Request for Class II Permissive Change(C2PC)

FCC ID: VG8XM0P04YY

Please be notified that we, the undersigned, **Guangdong Midea Kitchen Appliances Manufacturing Co., Ltd.** declare that the reasons for this class II permissive change are as below:

This is a C2PC application for which the previous grant was issued on 11/06/2022.

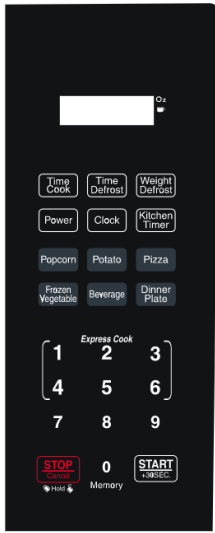
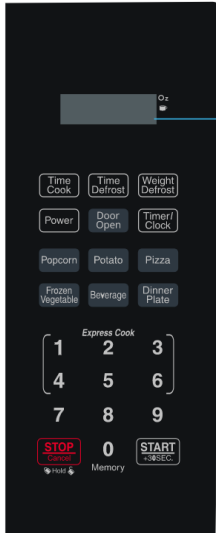
No.:	Original	New	Difference(s)
1			Keypad: Updated front keypad to accommodate child lock function (Child resistant oven door function)
2			Mother board: Modified the peripheral circuit (non-RF circuit) and some individual components and PCB layout. The magnetron and other circuit are exactly same as before
